TECHNICAL BULLETIN

[Issue No.] FA-A-0099

[Title] Enhanced compilation check function for structured ladder program in GX Works2 version 1.40S or later

[Relevant Models] Mitsubishi Integrated FA software MELSOFT series GX Works2

Example of program that causes a compilation error

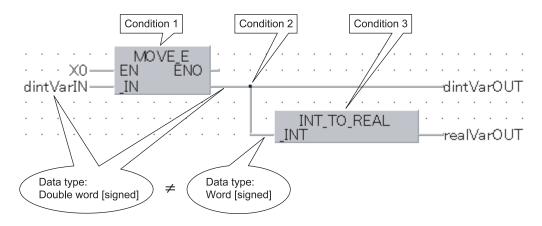
The compilation check function is enhanced to produce a compilation error when application functions with different data types are combined. A compilation error occurs when compiling a program in which all conditions from 1 to 3 as shown in the figure below are satisfied.

Condition 1: An application function with ANY type output, which contains argument EN/ENO, is used. (The relevant functions are listed in the following table.)

Condition 2: The output of the function in Condition 1 is branched.

Condition 3: The output data type of the function in Condition 1 is different from the input data type of the function in Condition 3 connected at the branched destination.

In the above program example, the output data of the "MOVE_E" function in Condition 1 is "double word [signed]" type because the input data type of the function in Condition 1 is "double word [signed]" type. The input data type of the "INT_TO_REAL" function in Condition 3 is "word [signed]" type, which is different from the output data type of the "MOVE_E" function in Condition 1.

Change the program to match the output data type of the function in Condition 1 with the input data type of the function in Condition 3.

Correction example: Change the "INT_TO_REAL" function in Condition 3 to the "DINT_TO_REAL" function whose data type is "double word [signed]" type.
